Work Order ID 146118

DESIGN <i>[Signature]</i>	DRAWN BY <i>[Signature]</i>	DART AEROSPACE LTD HAWKESBURY, ONTARIO, CANADA	
CHECKED <i>PH</i>	APPROVED <i>[Signature]</i>	DRAWING NO. D3303	REV. B SHEET 1 OF 4
DATE 06.08.17		TITLE HEAD REST	SCALE 1:3
REV	DATE	DESCRIPTION	
A	04.08.18	NEW ISSUE	
B	06.08.17	UPDATED FLAT PATTERN TO FORM PART IN ONE OPERATION USING OFFSET DIE

D3303-1 PLATE

DRAWING NO. D3303	TITLE HEAD REST	REV. B	DART AEROSPACE LTD ENGINEERING ORDER		D.E.O. NO. D3303-B-1	SHEET NO. SHEET 1 OF 1	SCALE NTS
DRAWN AJS	CHECKED <i>[Signature]</i>	MFG. APPR. <i>[Signature]</i>	APPROVED <i>[Signature]</i>		DE APPR. <i>[Signature]</i>		
DATE 08.10.15	DATE 08.10.15	DATE 08/10/16	DATE 08/10/16		DATE 08/10/16

D3303-041 HEAD REST

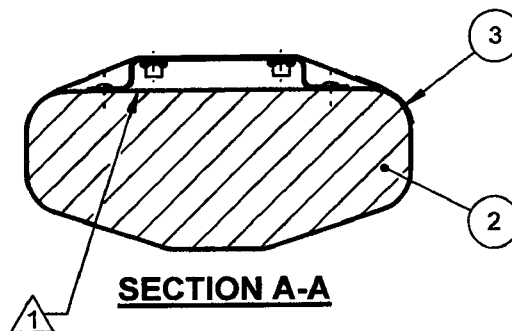
SHEET 1 ADD 1300L ADHESIVE BY 3M TO NOTE 1 AS FOLLOWS:

WAS:

NOTES:

- 1) BOND D3305-1 FOAM TO D3303-043 BRACKET ASSEMBLY USING 3M 1300 ADHESIVE (0.002" TO 0.010" THICK) IN ACCORDANCE WITH MANUFACTURER'S INSTRUCTIONS

SEE NCR 08-069 FOR FURTHER DETAILS

IS:

NOTES:

- 1) BOND D3305-1 FOAM TO D3303-043 BRACKET ASSEMBLY USING 3M 1300 OR 1300L ADHESIVE (0.002" TO 0.010" THICK) IN ACCORDANCE WITH MANUFACTURER'S INSTRUCTIONS
